# Construction Traffic Management Plan – Pitt Street South Site – Demolition Works Amendment 1

Project: Sydney Metro City & Southwest – TSE Works

Document No: SMCSWTSE-JCG-SPS-TM-PLN-002288

**RE: Endorsement of Construction Traffic Management Plan – Pitt Street South Site - Demolition Works Amendment 1: Sydney Metro City & Southwest – TSE Works**

DRAWING No: SMCWSTSE-JCG-SPS-TM-TCP-002288-0002

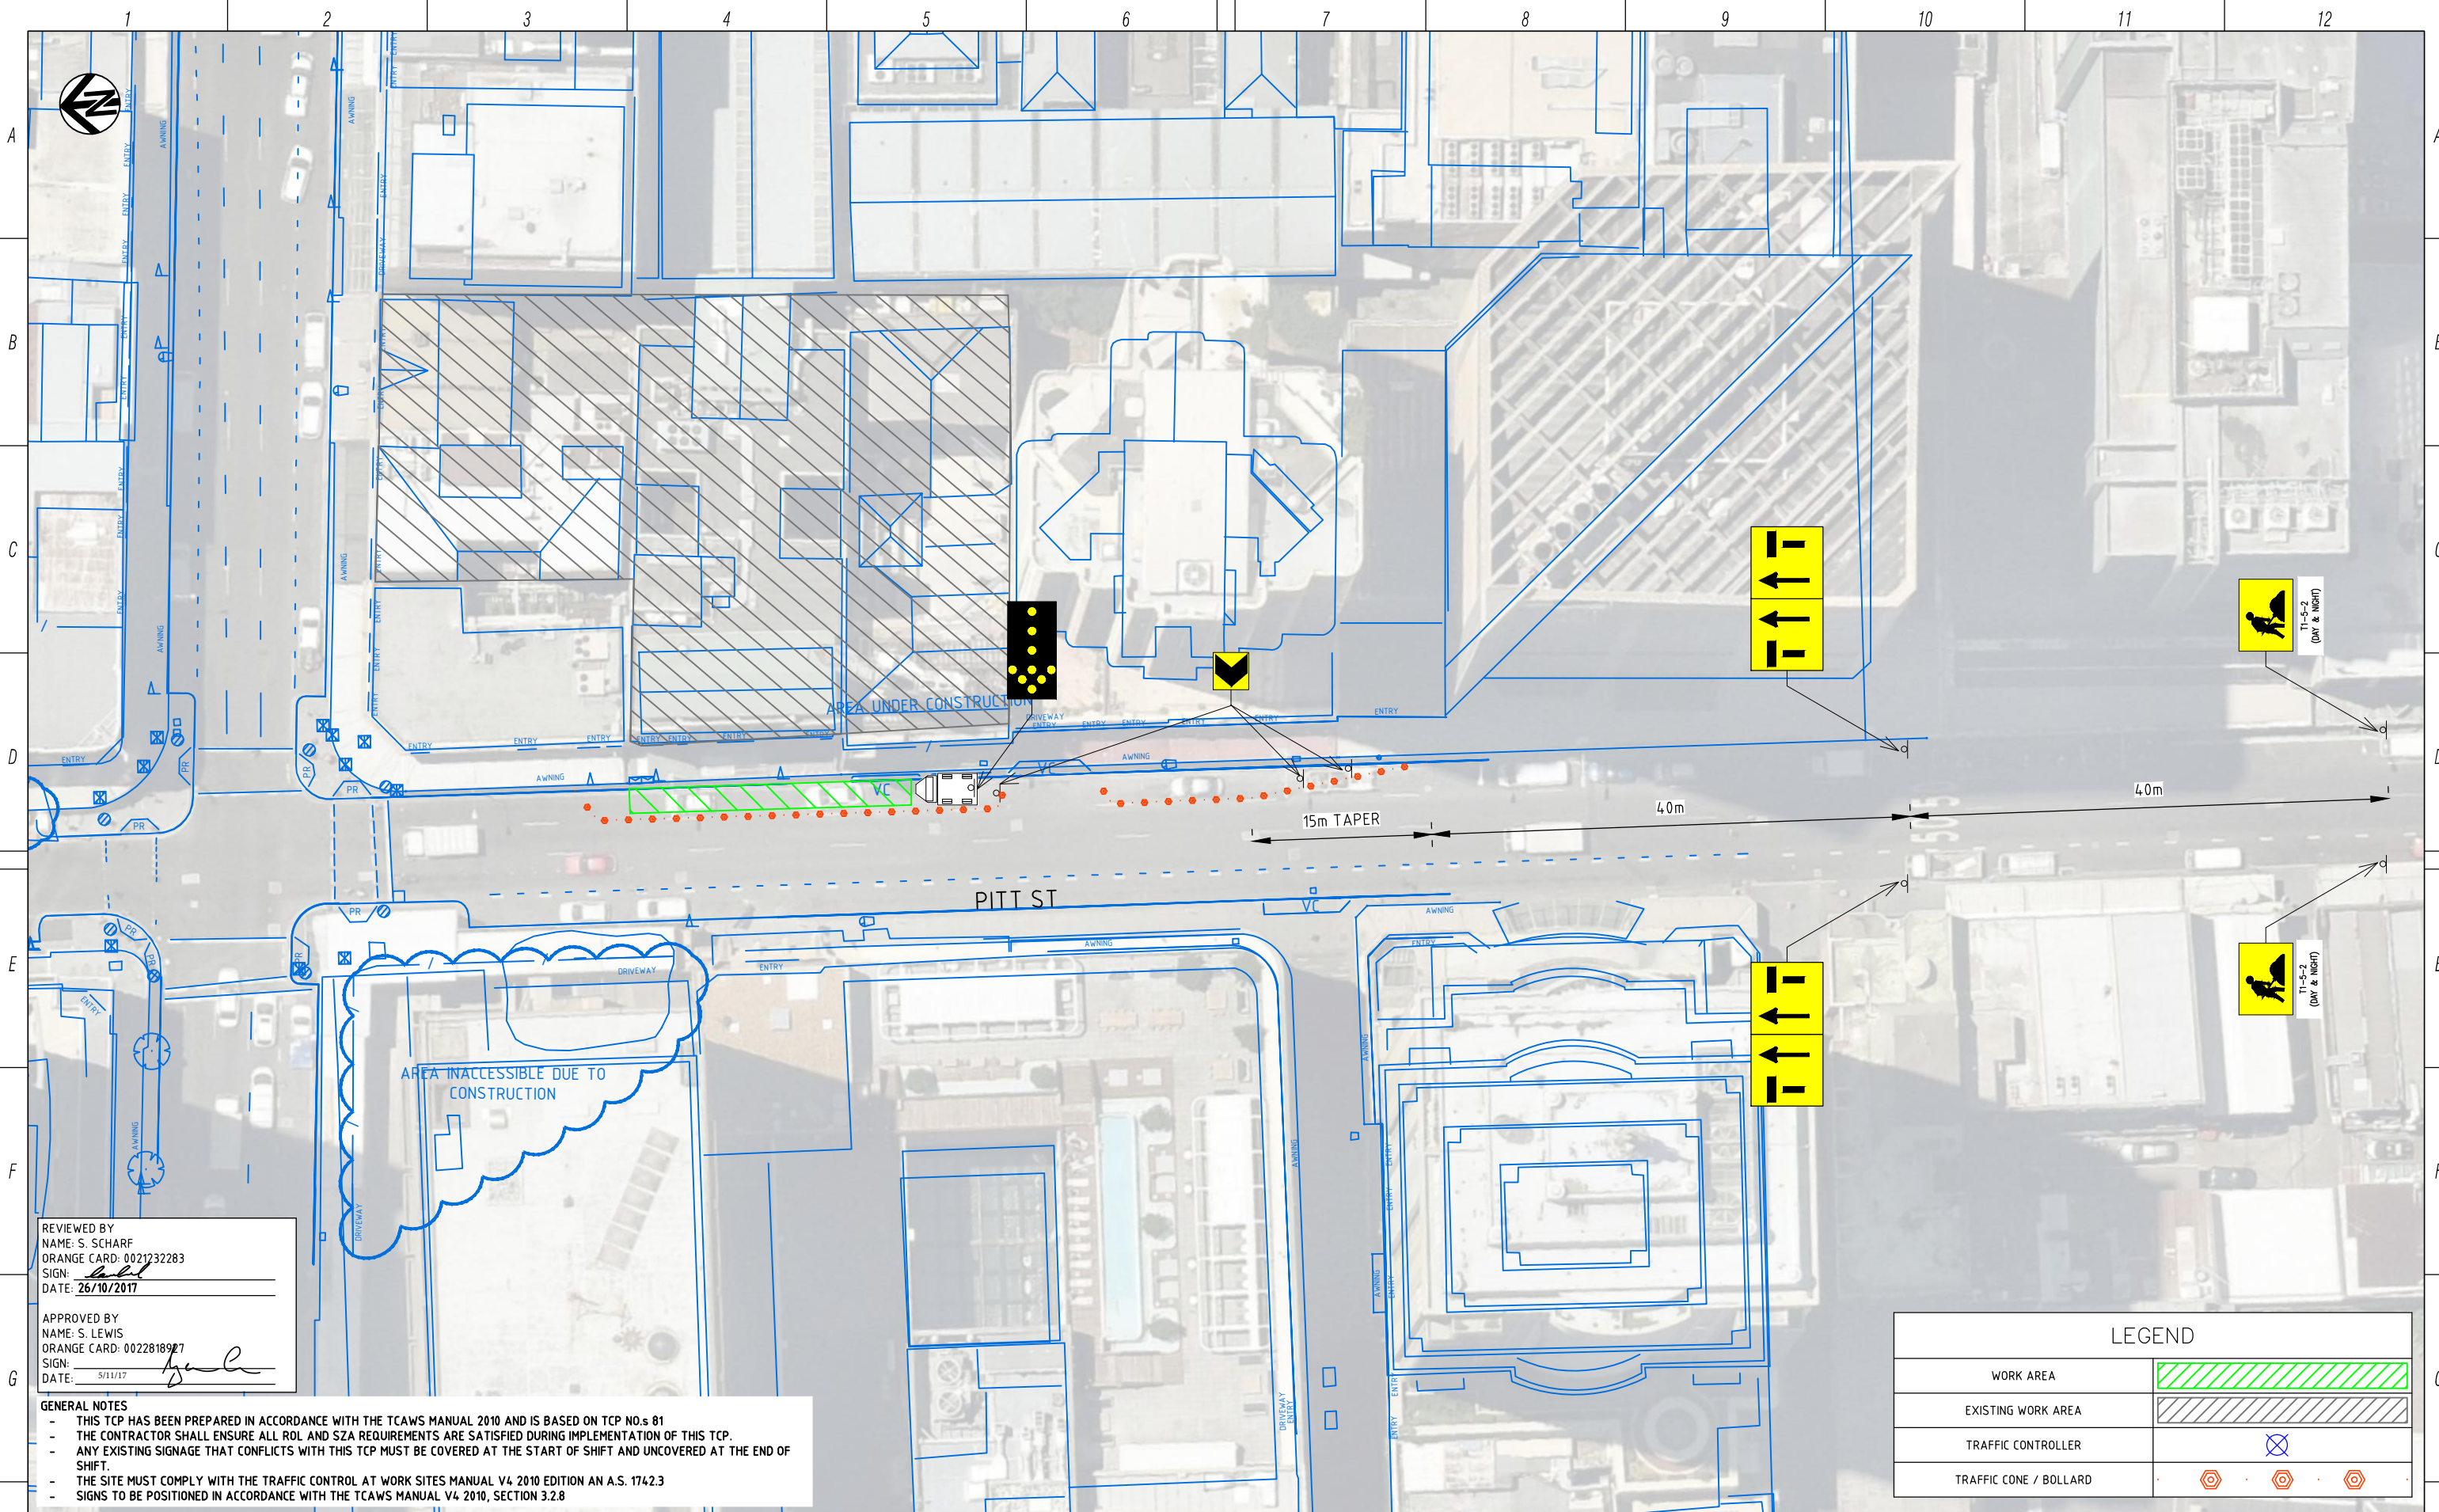
Item	Section/ Page	Comments	Response
4	Appendix 3 SMCWSTSE-JCG-SPS-TM-TCP-002288-0002	The report will have to specific the position and number of traffic controllers that will be used to assist pedestrians cross the two parking lane and two traffic lanes. Note that traffic controllers are only able to manage one traffic lane at a time	Assume this is 0003 drawing – two traffic controllers are already shown on the drawing.
